Pulaski County Schools
Energy Savings and Performance Contract
Addendum #2
March 25th, 2022

CMTA Contact:	Megan Brangers
Email:	MBrangers@cmta.com
Cell Phone:	502-919-1521

The following information supersedes or is in addition to information released in the Contract Documents dated March 11th, 2022 and addendum 1 dated March 18th, 2022.

PARTIAL FIRST FLOOR PLAN (AREA C) - MECHANICAL
SCALE: 1/8" = 1'-0"
1
M1-3.1C

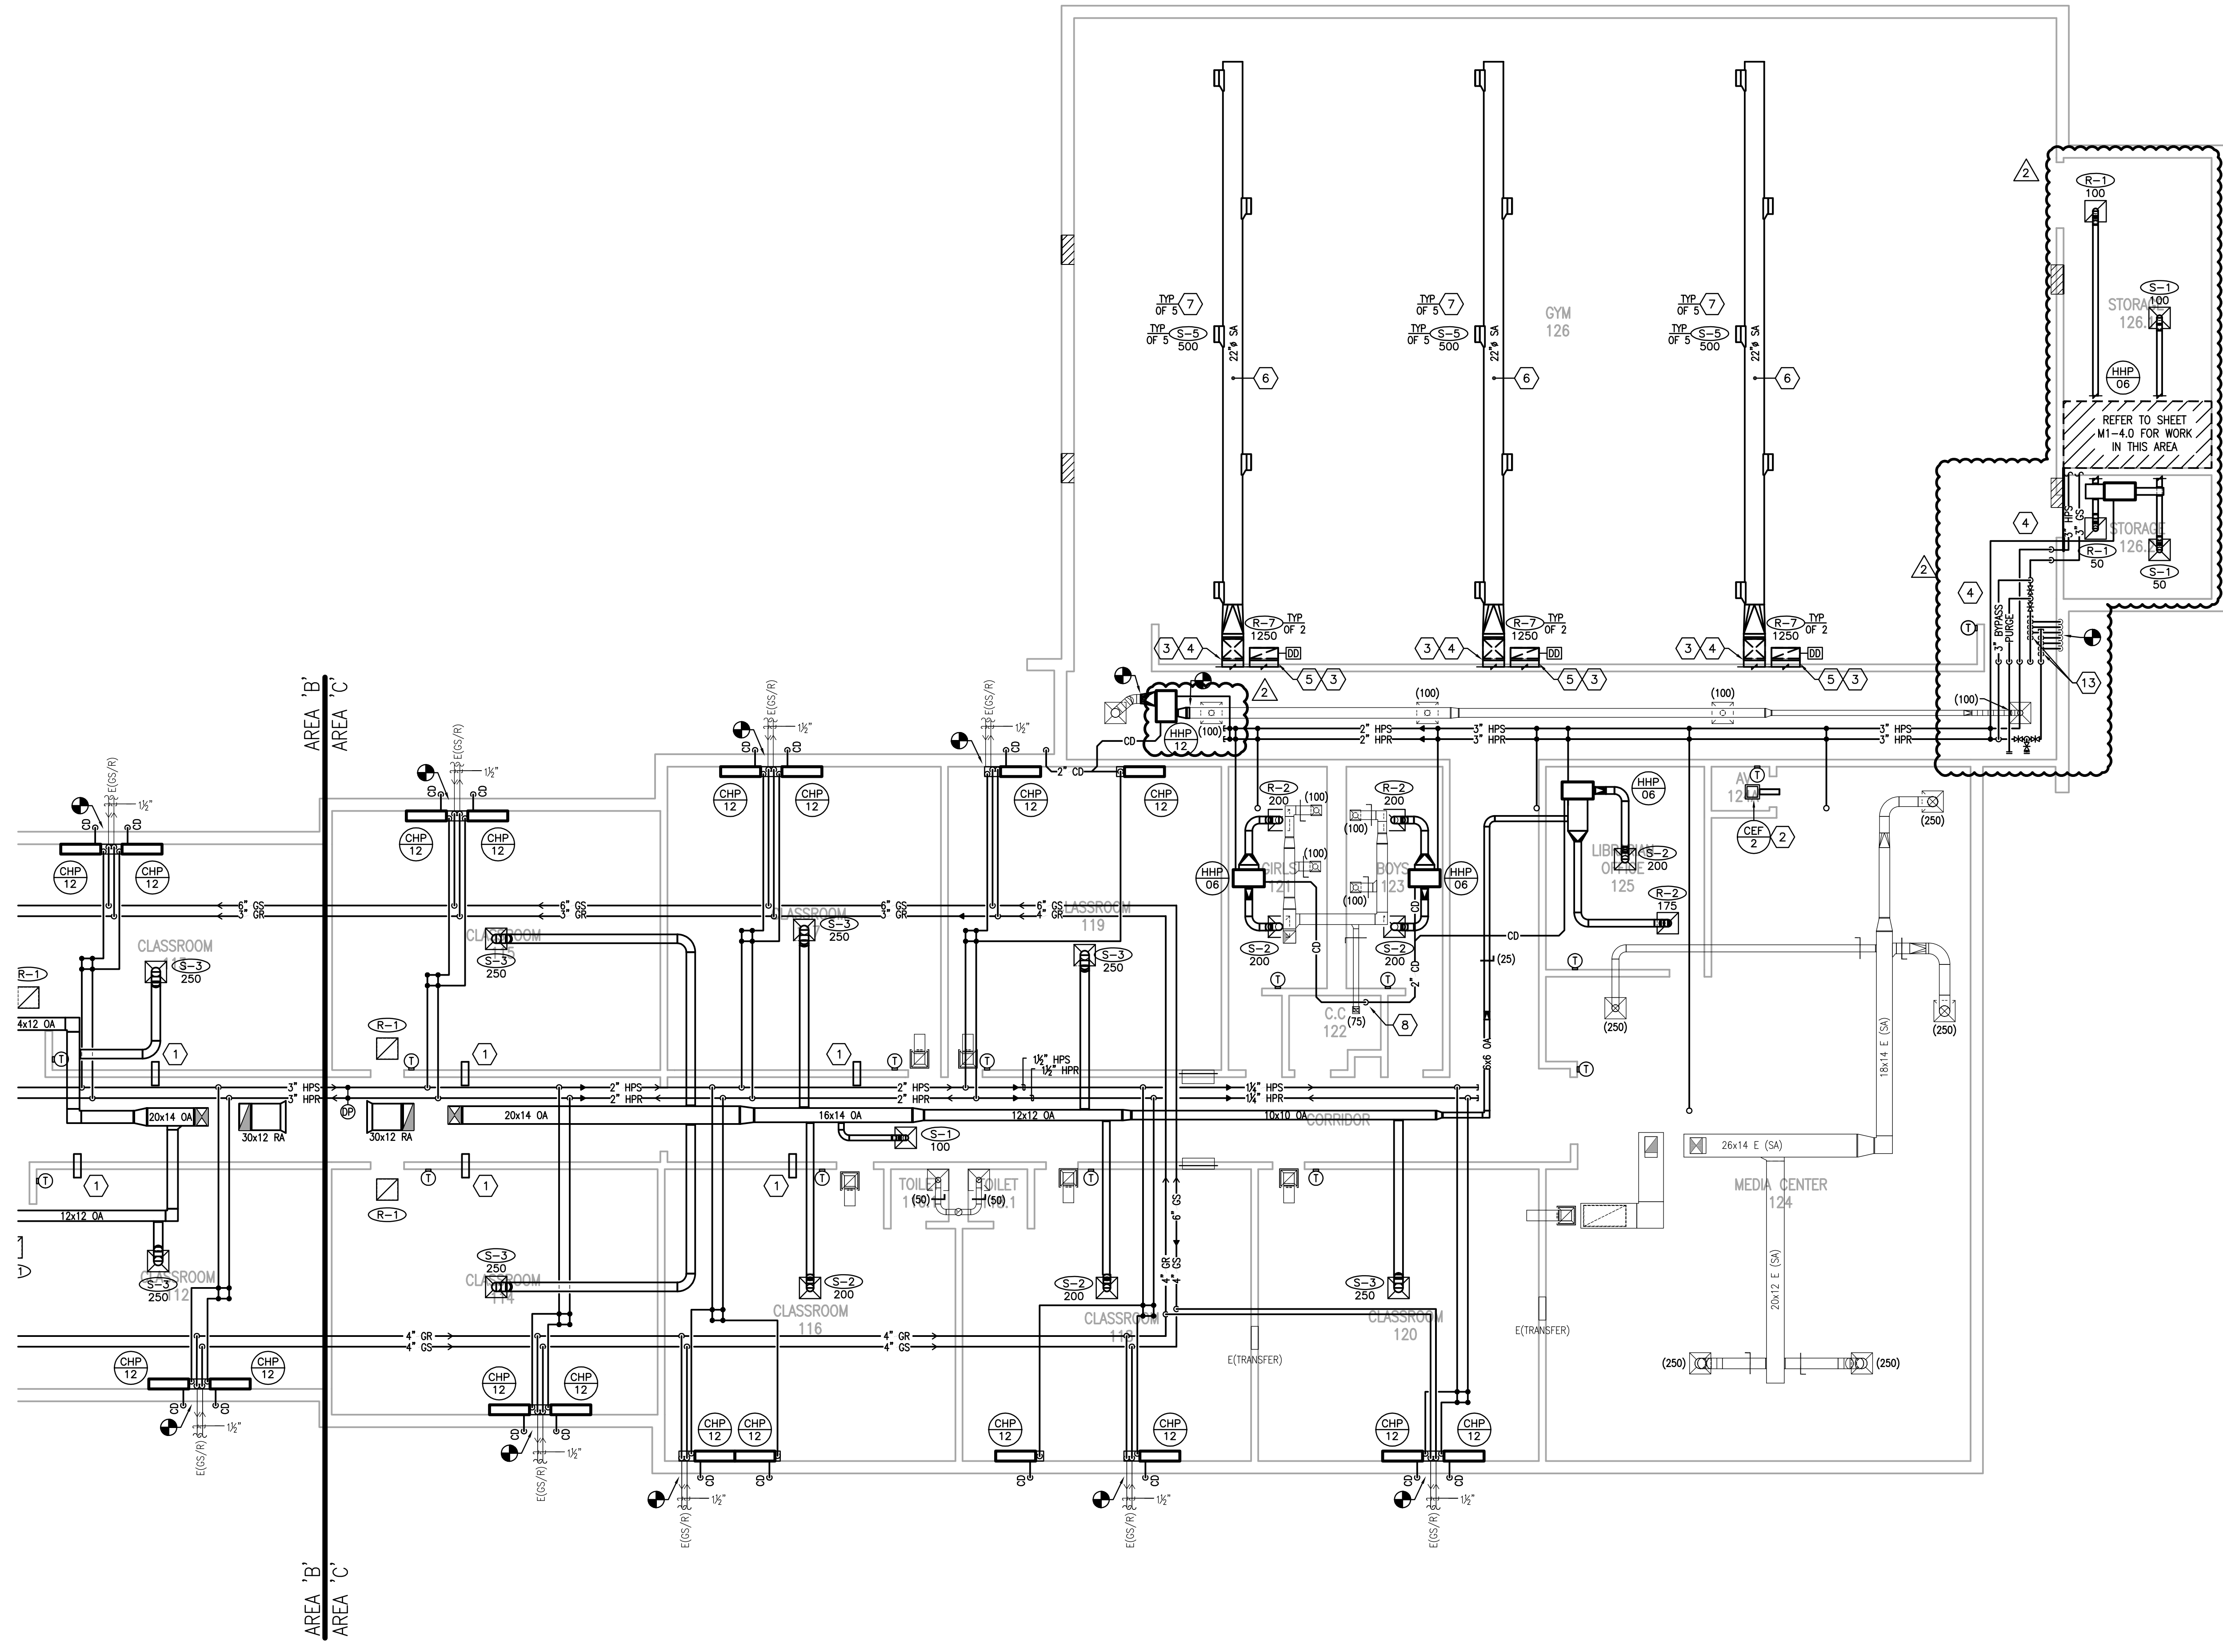
7. Drawing M1-3.1C
 - a. Refer to the Gym 126 and adjacent corridor for revised geothermal and heat pump piping. Add geothermal wellfield bypass and purge ports.

- b. Refer to Storage 126.1 and Storage 126.2. Add HHP-06 to serve both rooms.
 - c. Refer to corridor adjacent to Gym 126. Add HPS/R take-off from main to HHP-12.

- d. Refer to Gym 126. Remove two thermostats.
 - e. Refer to Gym 126. Route 3” HPS and 3” GS down wall and through storage 126.2.
8. Drawing M1-3.2
 - a. Omit tag note 6.

M1-4.0

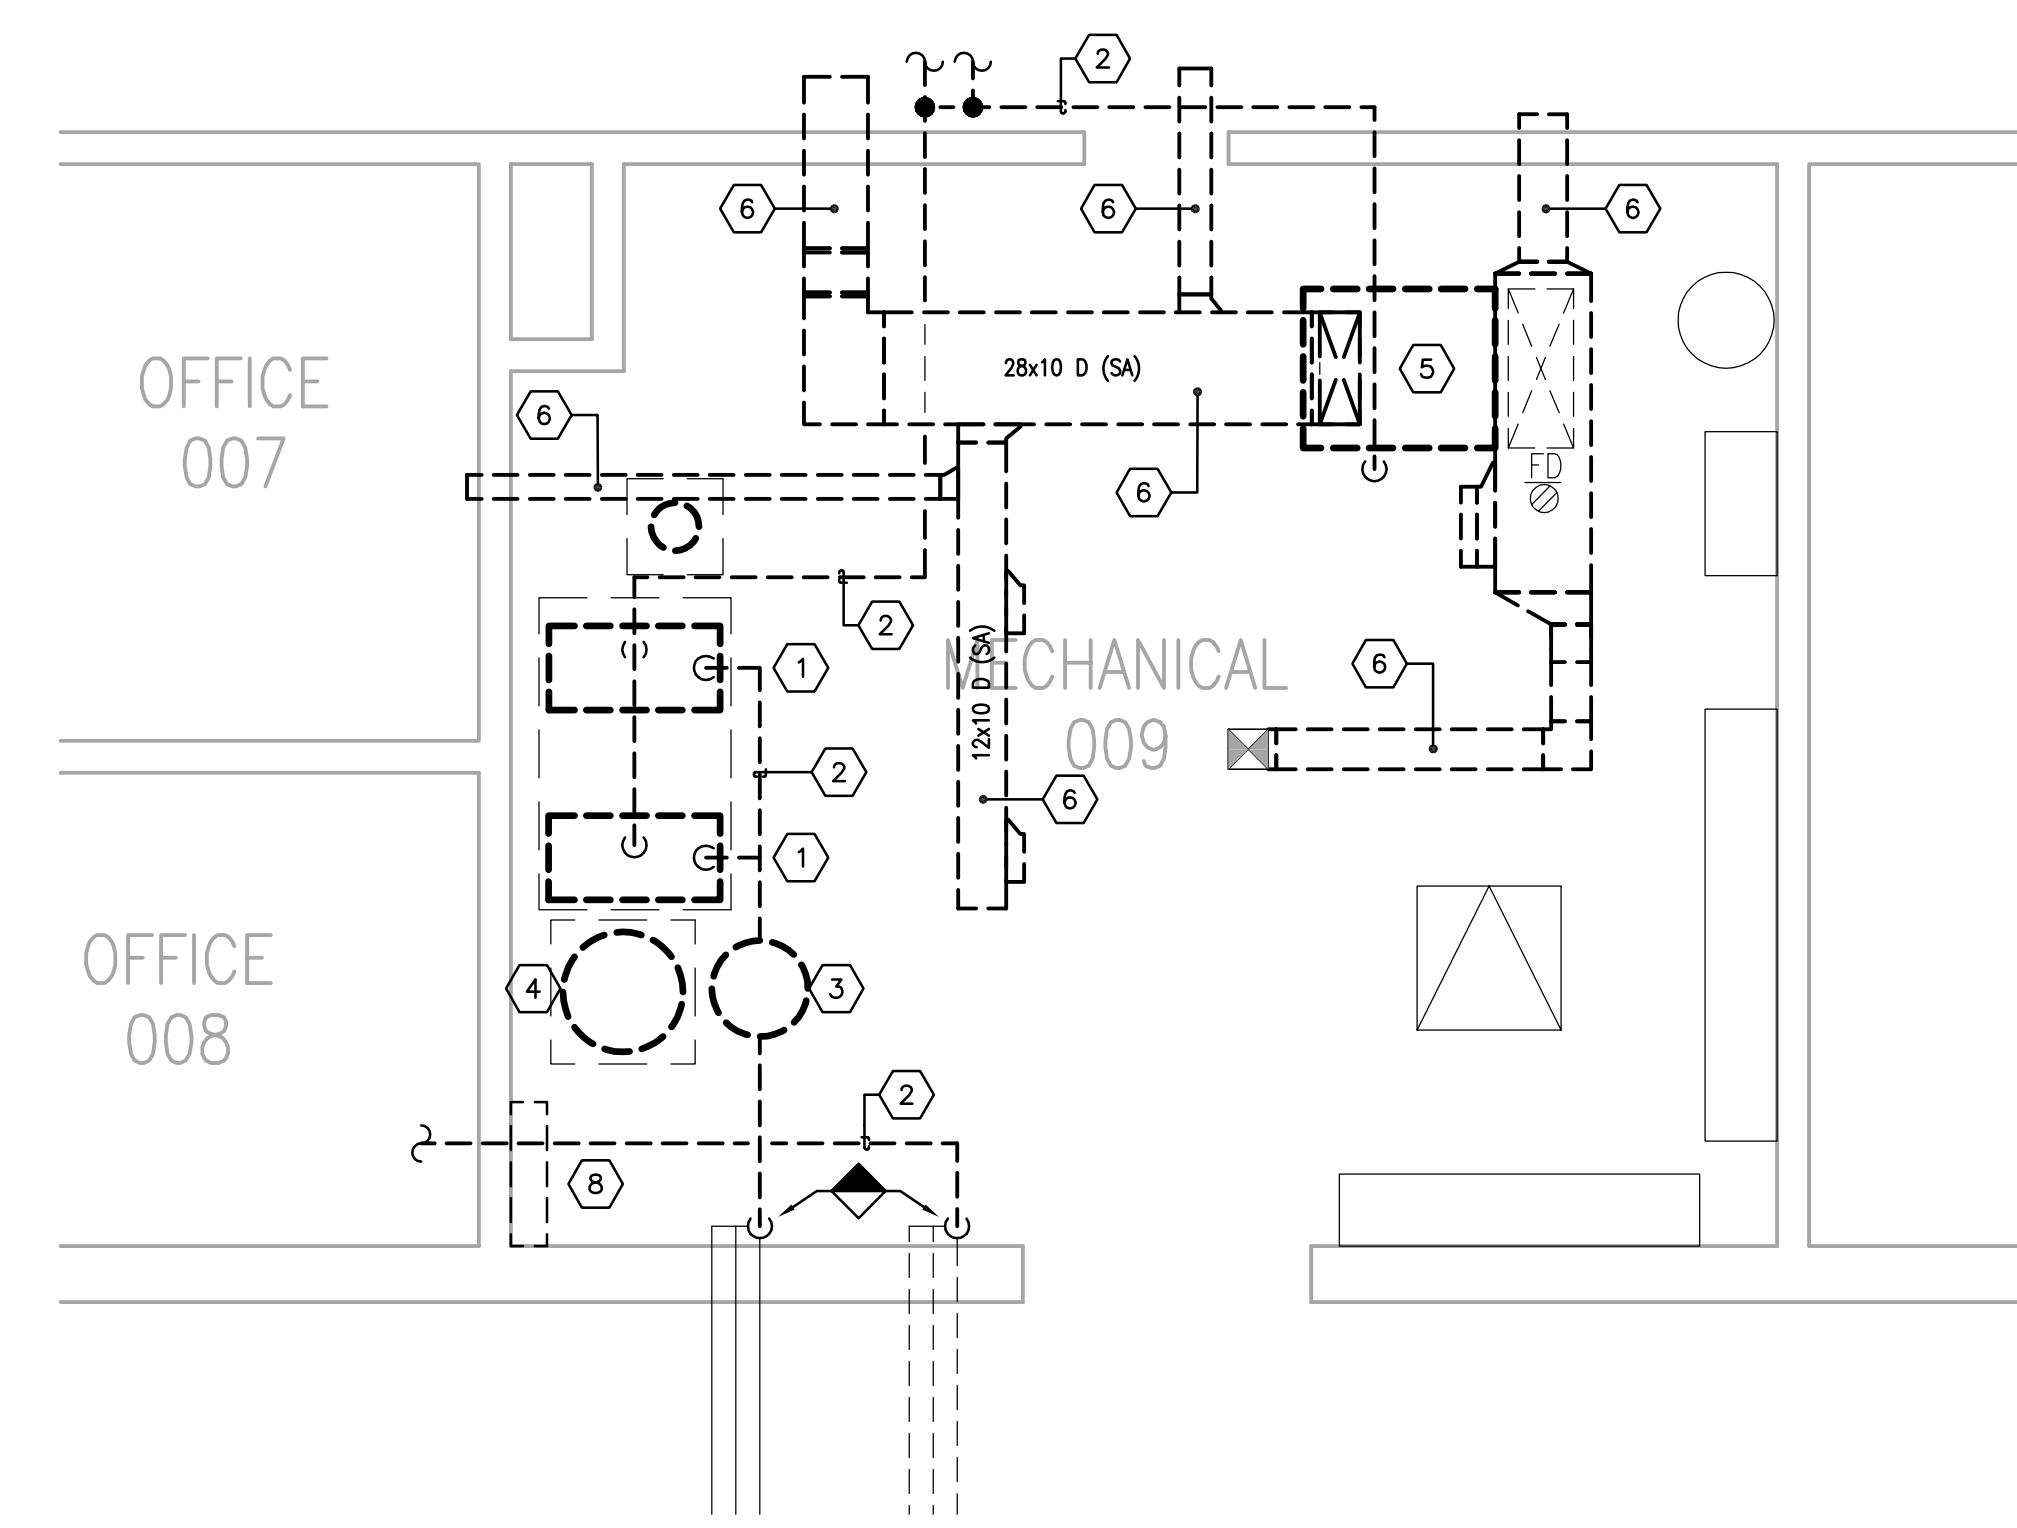
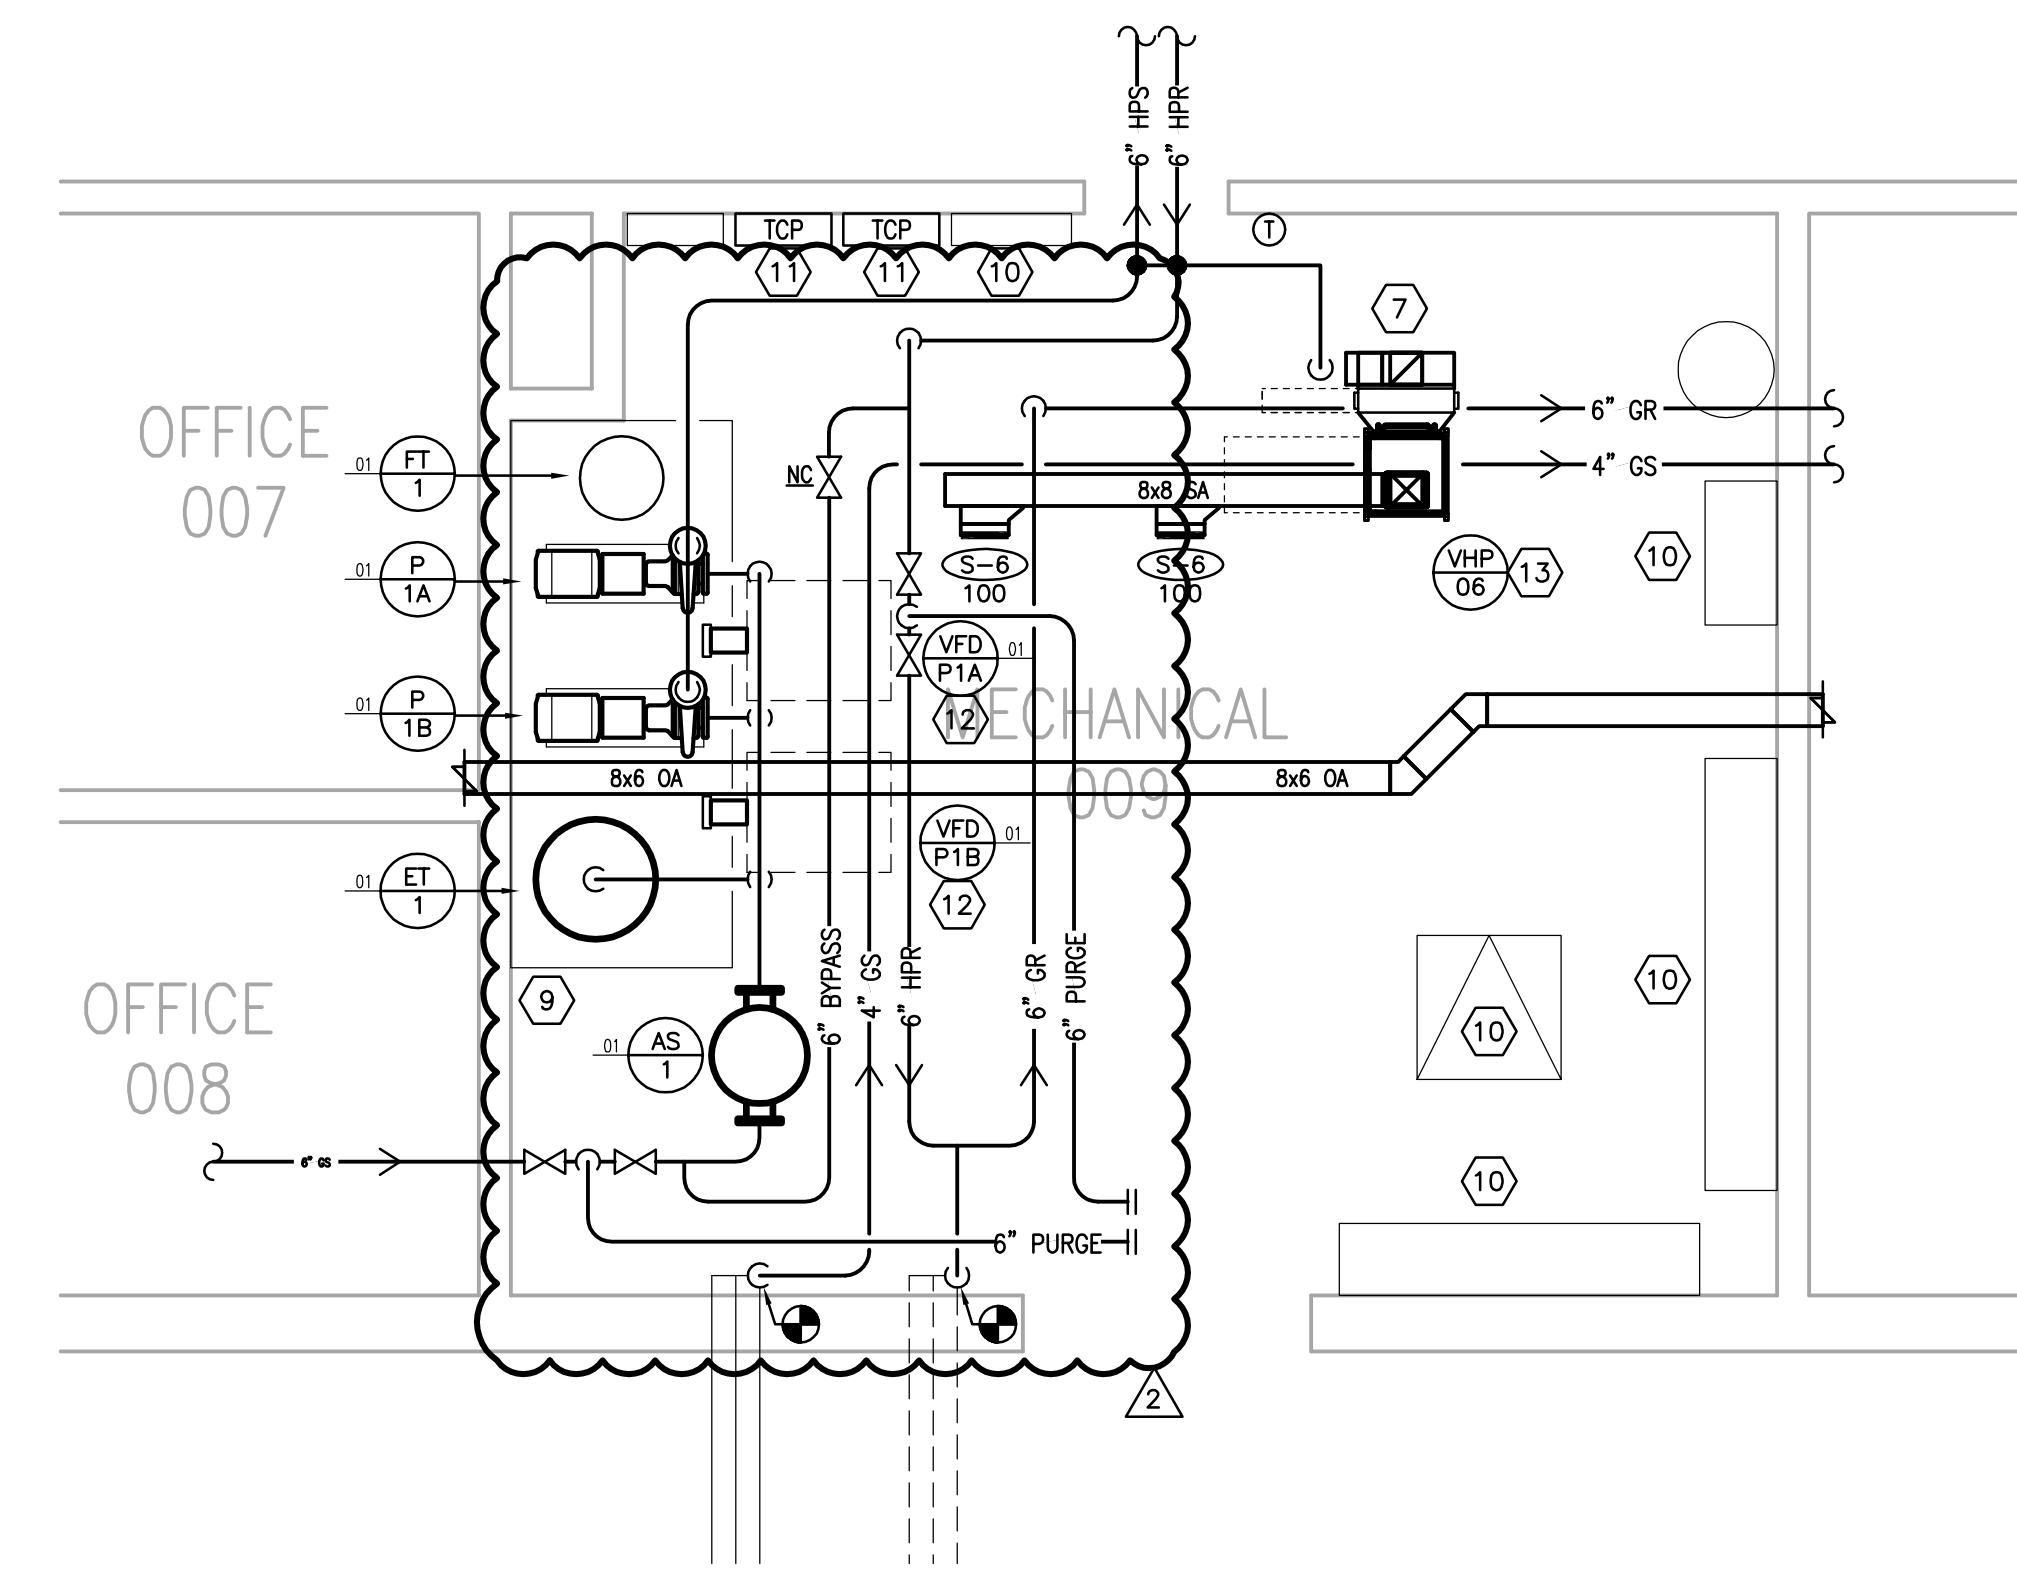
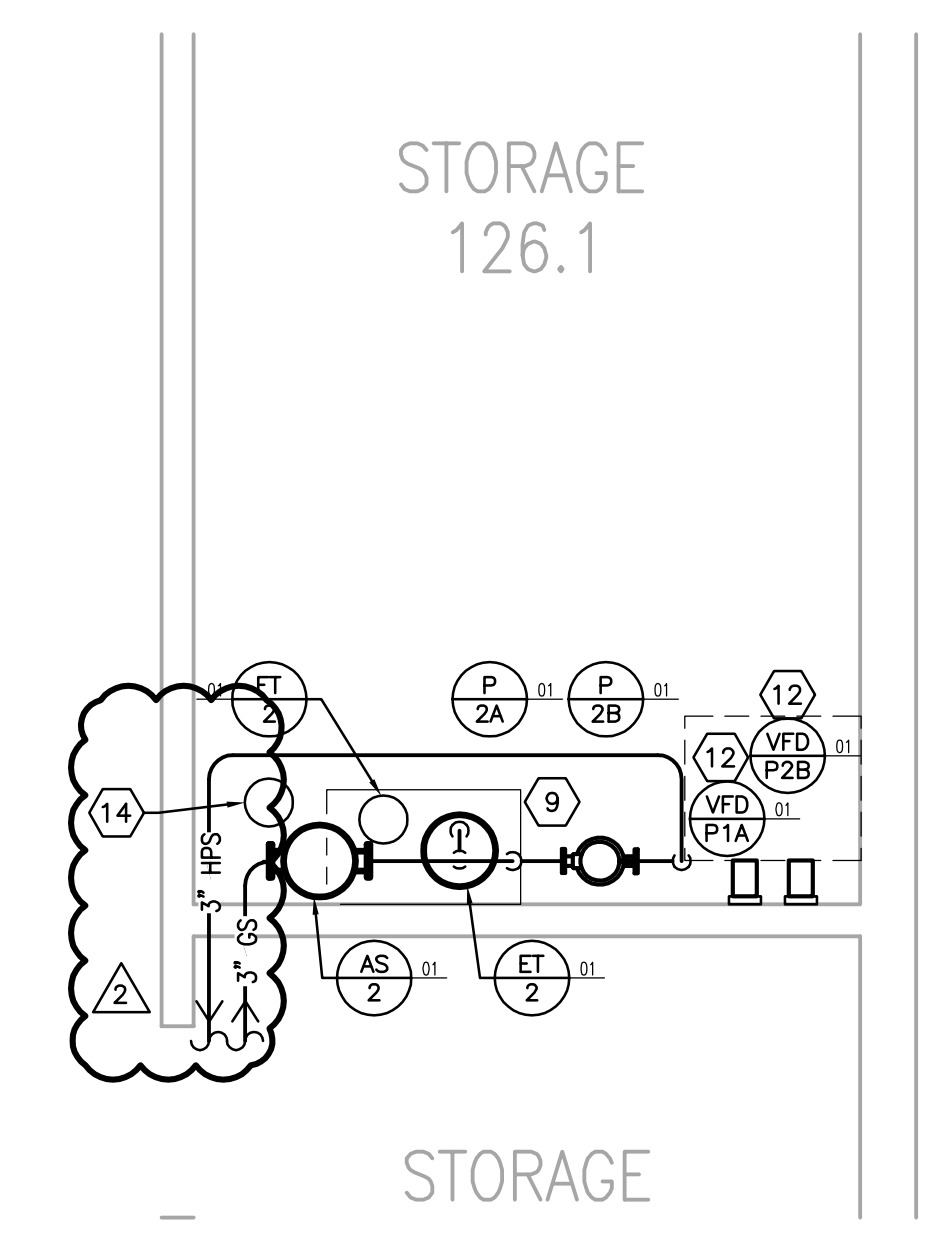
9. Drawing M1-4.0

- a. Refer to Mechanical 009 for revised geothermal and heat pump piping loops / system. Add geothermal wellfield bypass and purge ports.
- b. Refer to Storage 126.1. Add 5-gallon pot feeder.
- c. Update Enlarged Mechanical Rooms Tag note 1 to read: "EXISTING PUMPS TO BE COMPLETELY REMOVED INCLUDING ALL EXISTING MECHANICAL, ELECTRICAL AND CONTROLS CONNECTIONS. CONCRETE PAD SHALL BE REMOVED IF APPLICABLE; PATCH AND SMOOTH FLOOR AS REQUIRED."
